To: Prospective Bidders
From: Wold Architects and Engineers
Date: April 15, 2013
Comm. No: 124008

Subject: Addendum No. 2 for Bidding Documents for the: **Annapolis High School Pool
Improvements and Boiler Replacement
Dearborn Heights, Michigan 48125**

REVISIONS: 1 ADDENDUM No. 2

R1
A1.01

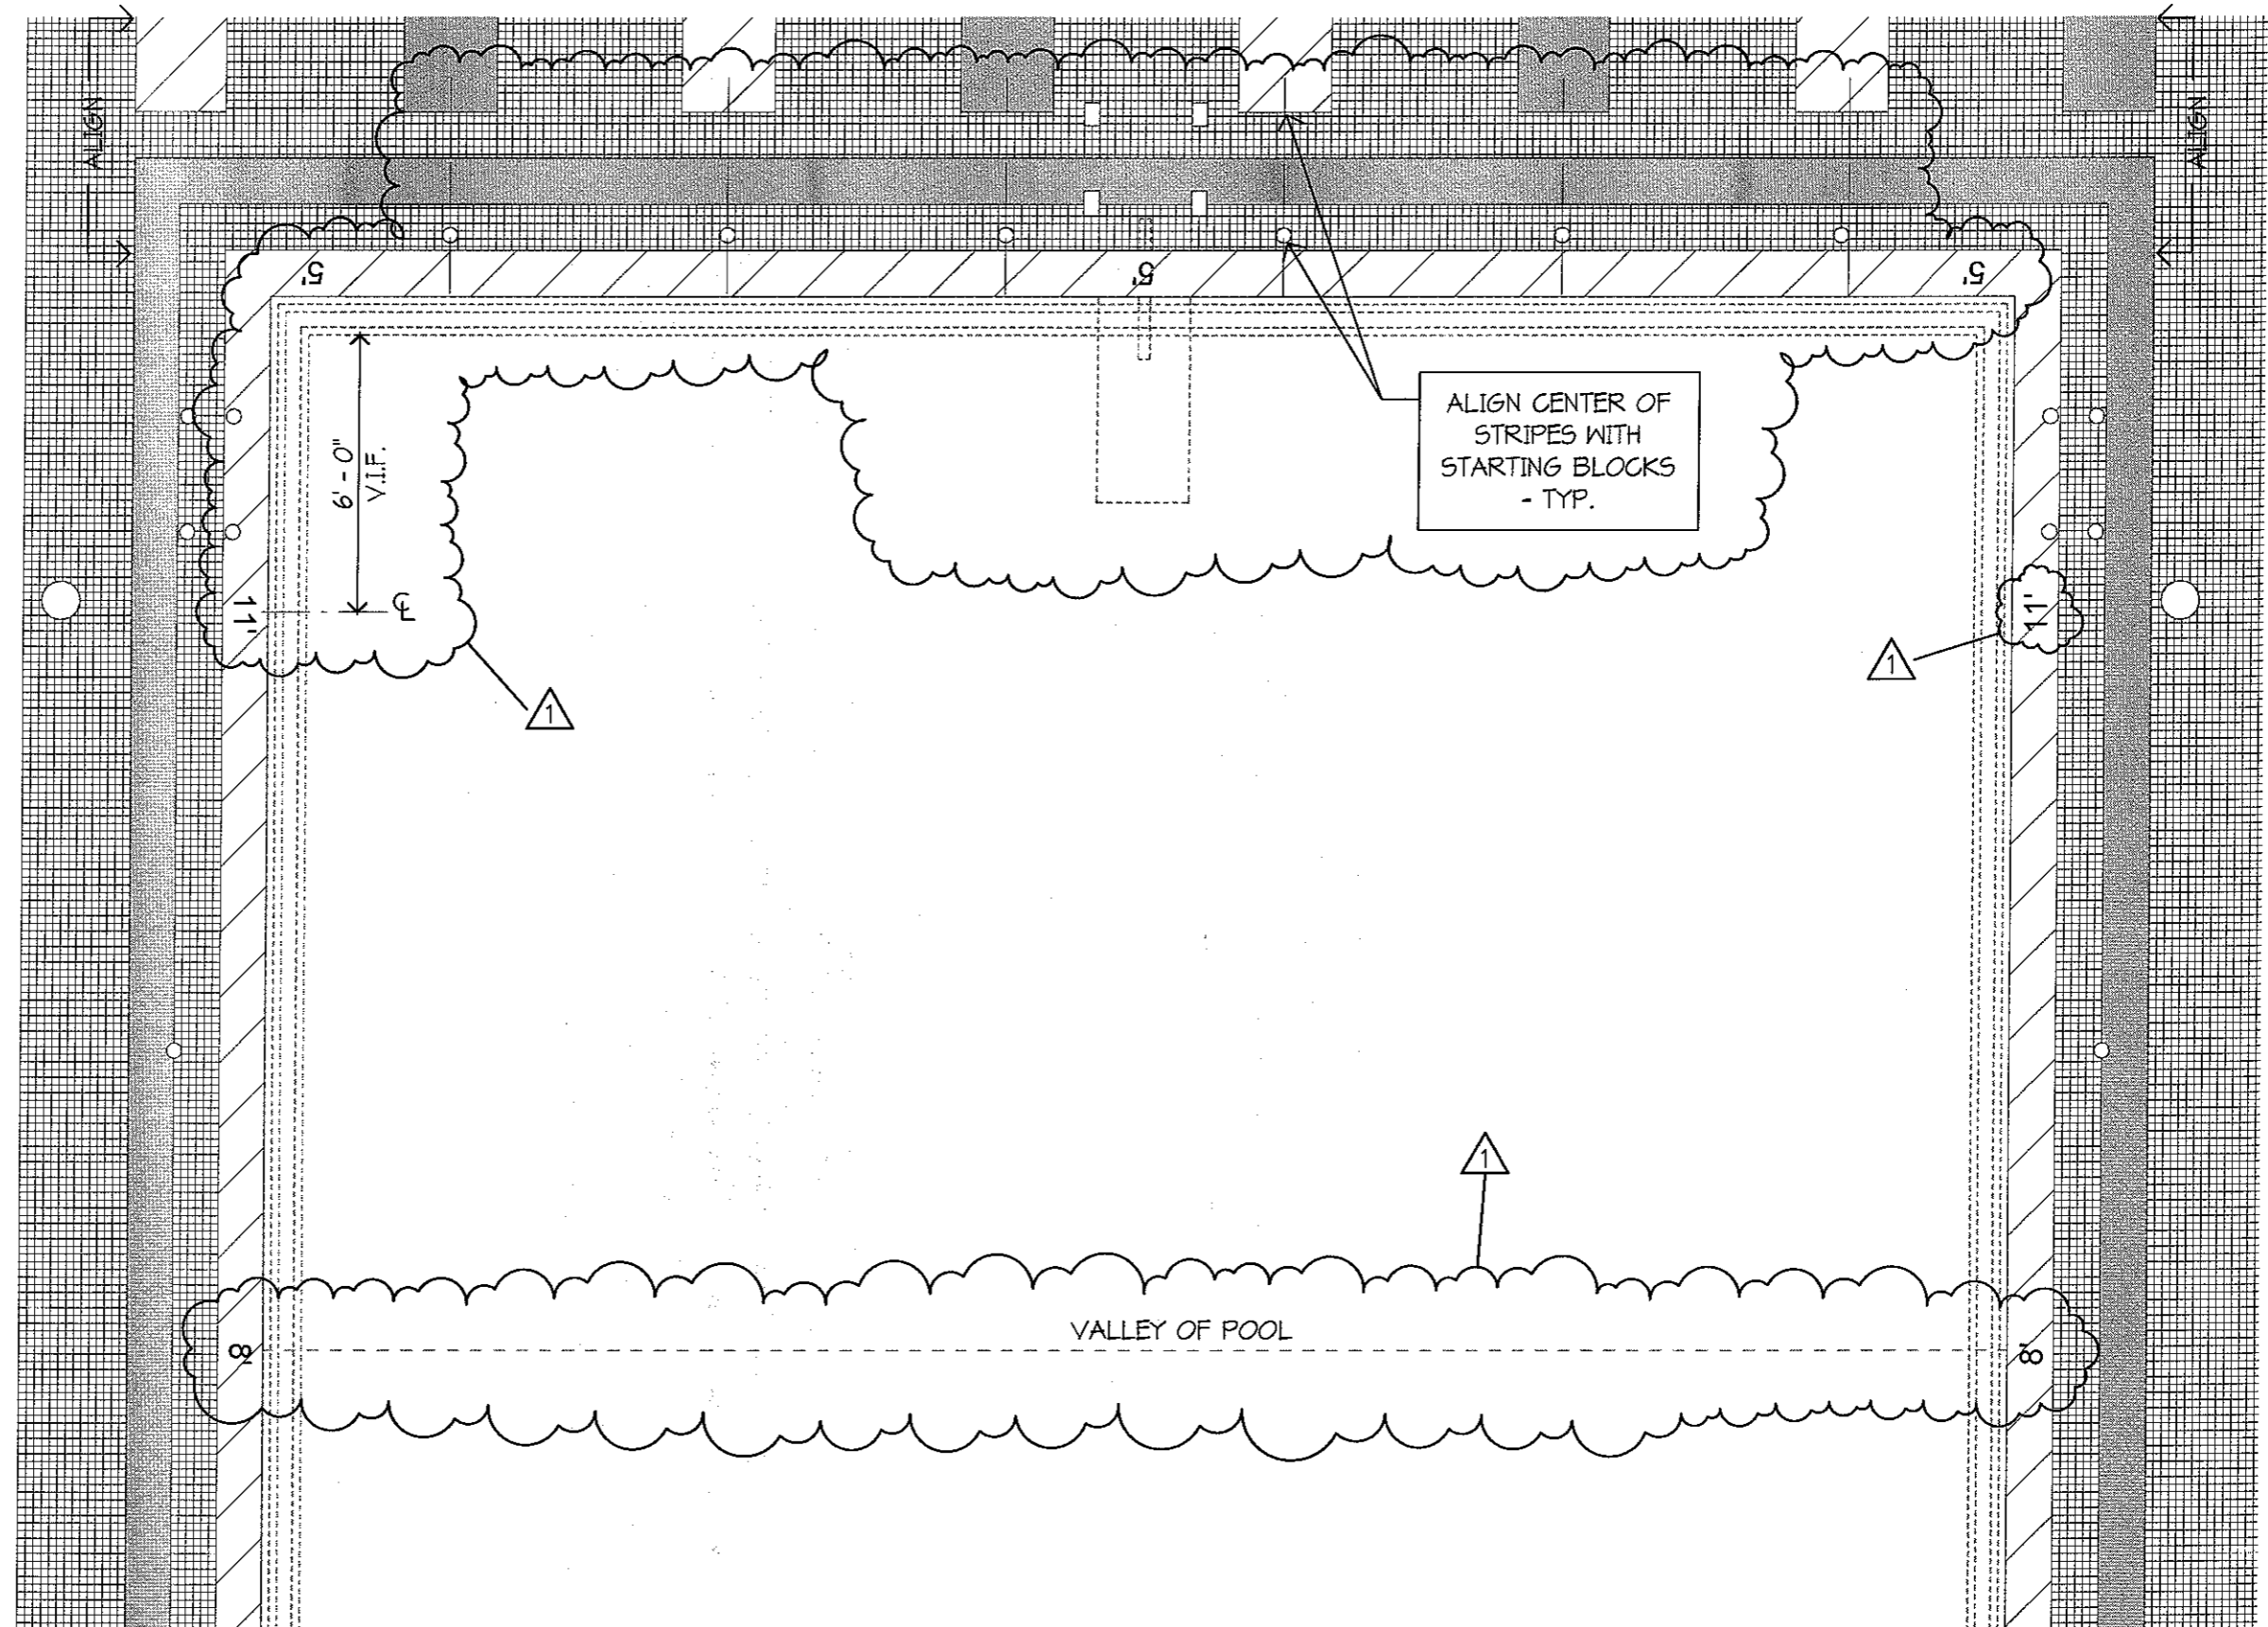
- A. Add enlarged detail plan bubble on Drawing F1/A1.01 MAIN LEVEL FLOOR PLAN – AREA 'A' (not re-issued) per R1/A1.01 (issued).
- B. Add Room Finish Schedule, per R2/A1.01 (issued).

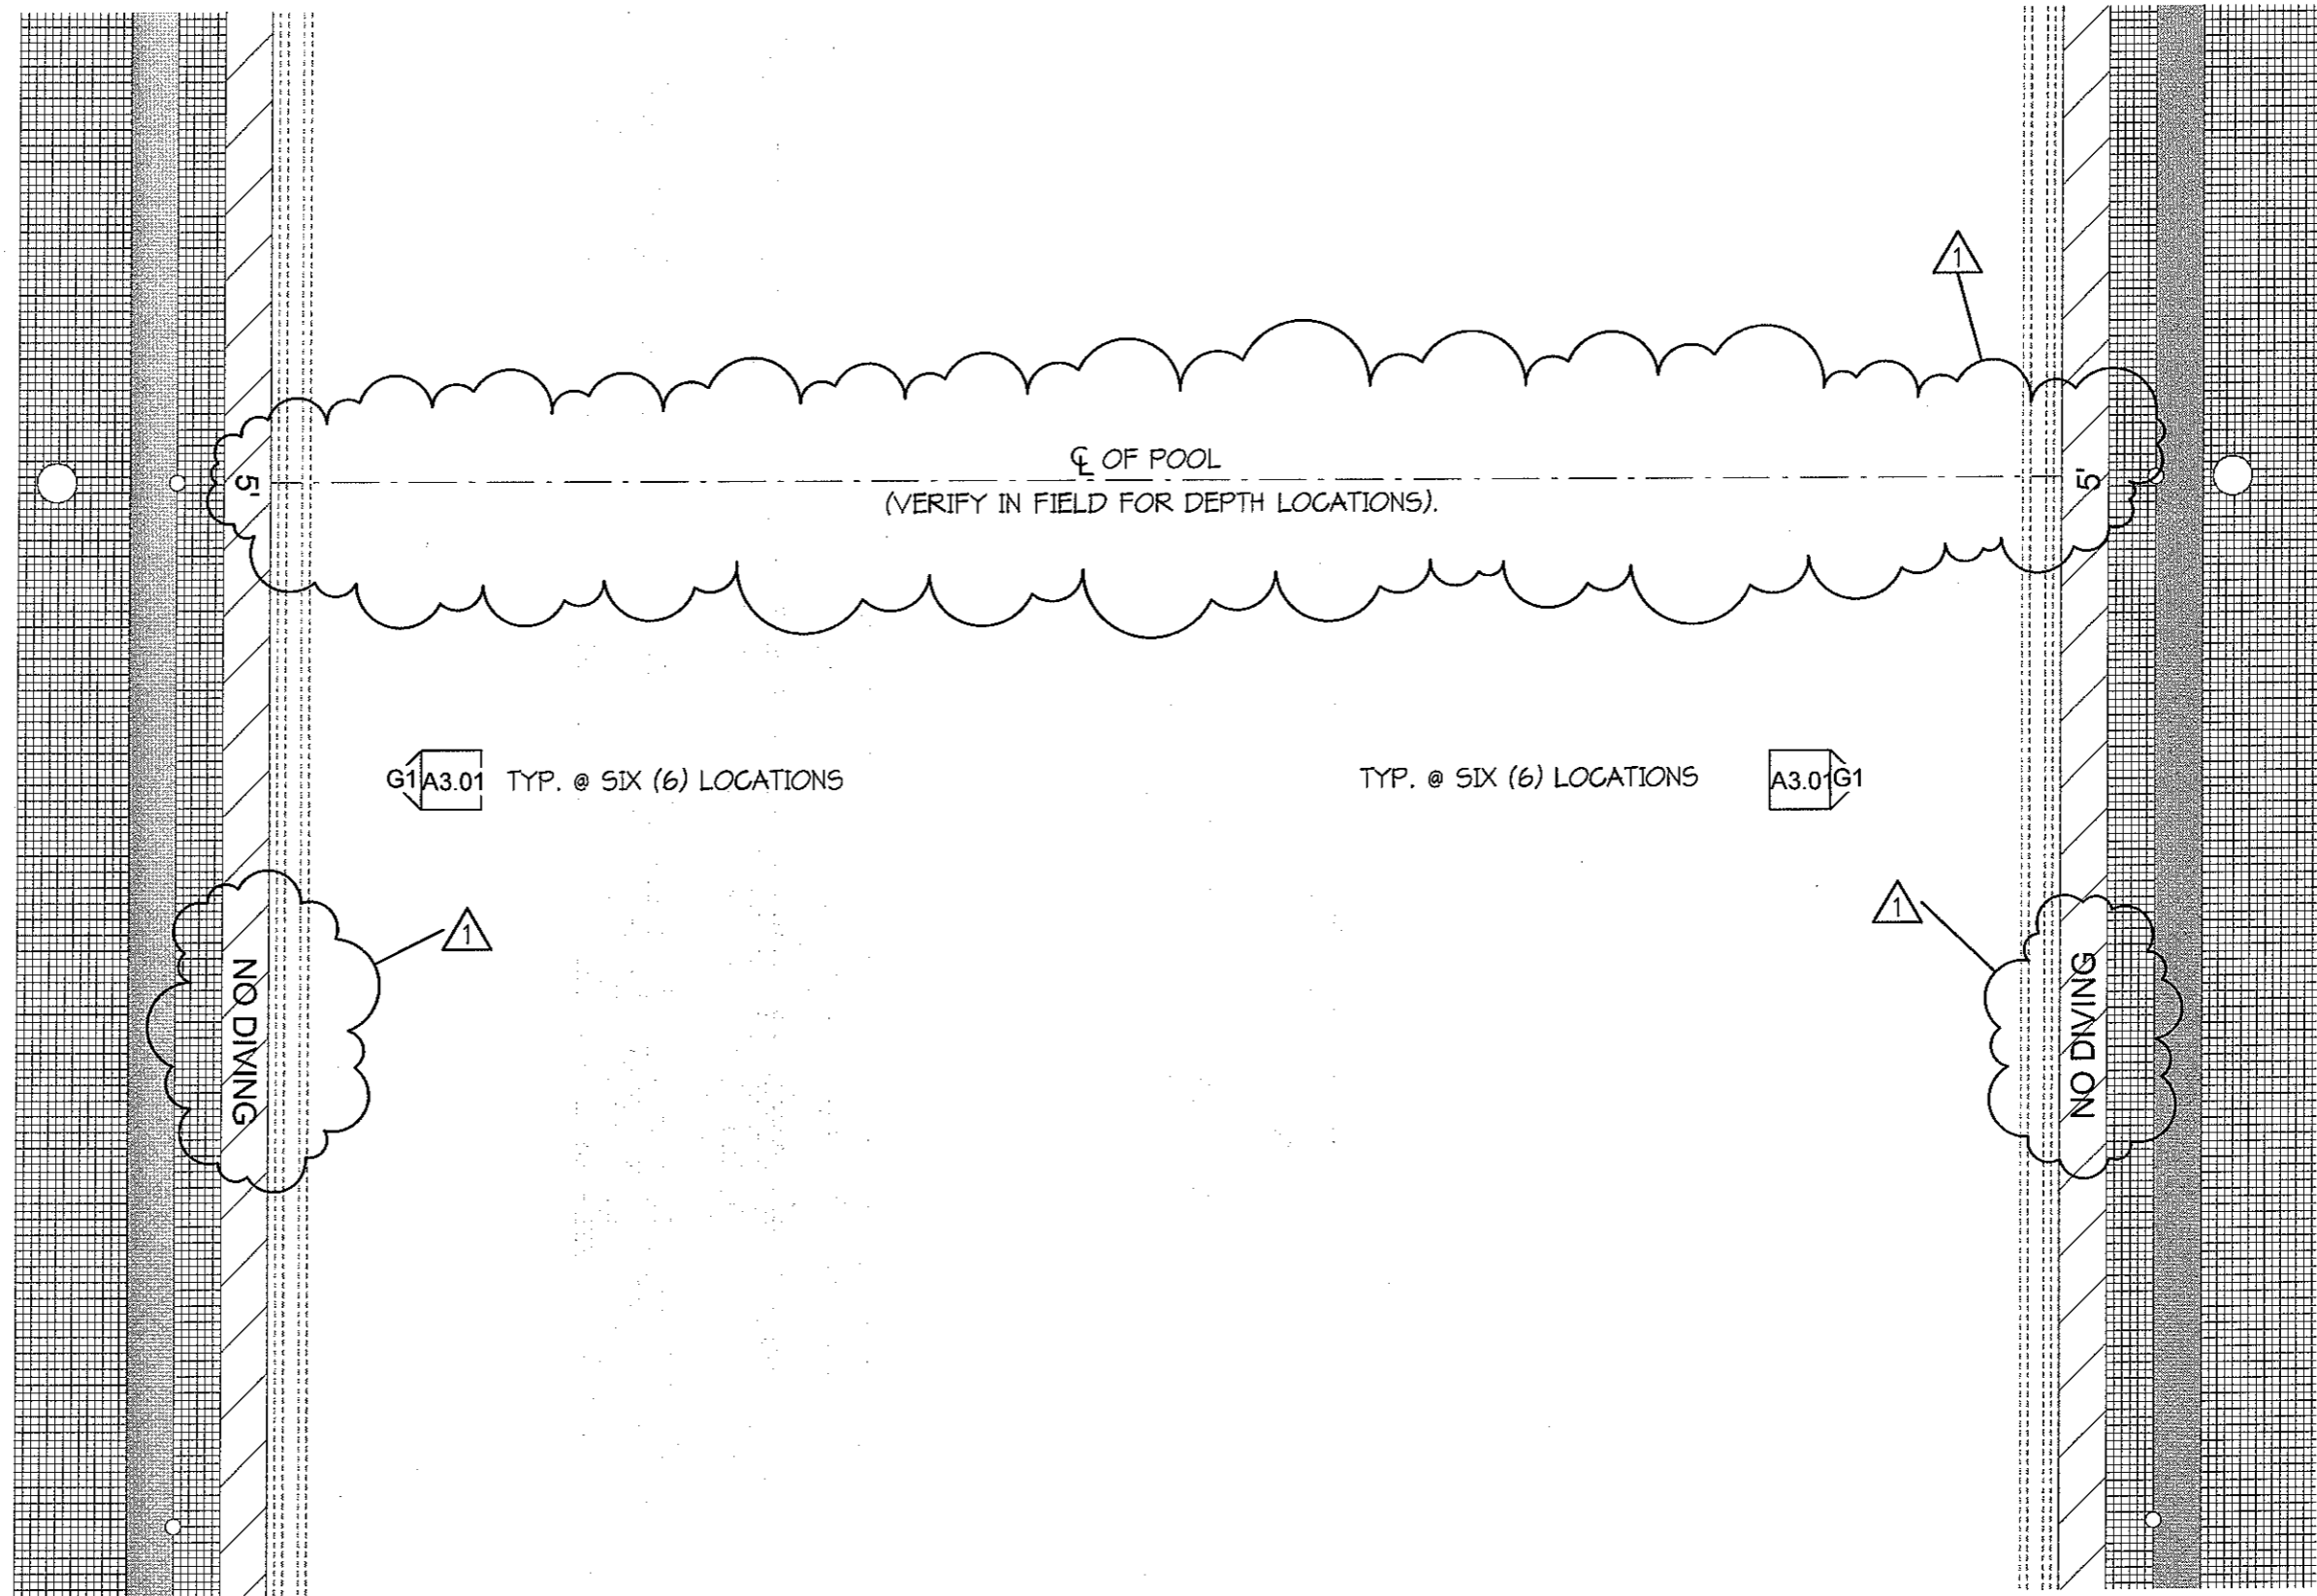
- A. See drawing E1/A3.01 "POOL TILE PATTERN" (not re-issued), add 6" lettering around pool deck per attached R1/A3.01, R2/A3.01, and R3/A3.01 (issued).
- B. See Drawing E1/A3.01 "POOL TILE PATTERN" (not re-issued), revise note on west end of pool that reads: "NOTE: ALIGN PATTERN WITH PATTERN AT EAST END OF POOL" to read "ALIGN CENTER OF STRIPES WITH STARTING BLOCKS - TYP." (See R1/A3.01 (issued)).

H1 TYPICAL TILE LETTERING DETAIL
3" = 1'-0"

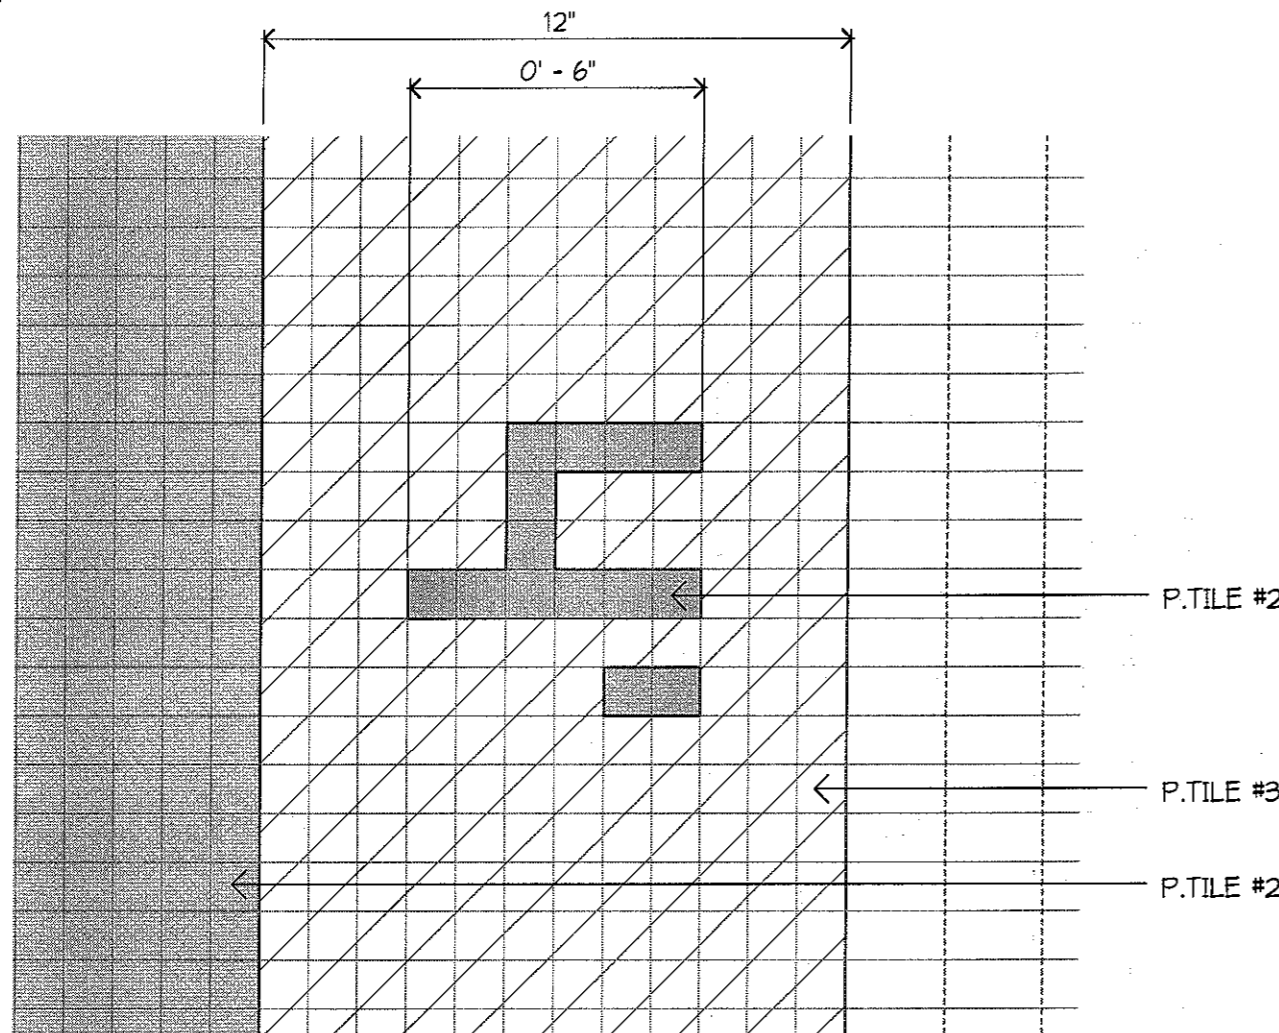
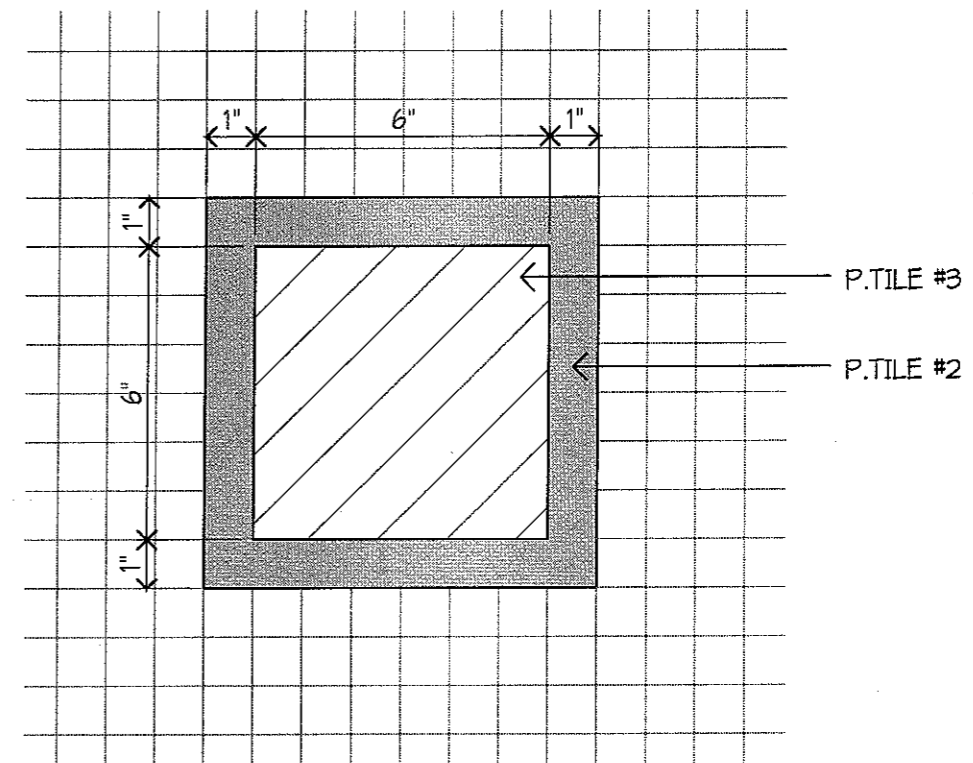
- D. See Drawings A3.01 (not re-issued), revise the "FLOOR FINISH LEGEND", per attached R4/A3.01 (issued).
- E. Add Detail H1/A3.01, "TYPICAL TILE LETTERING DETAIL", per attached R4/A3.01 (issued).
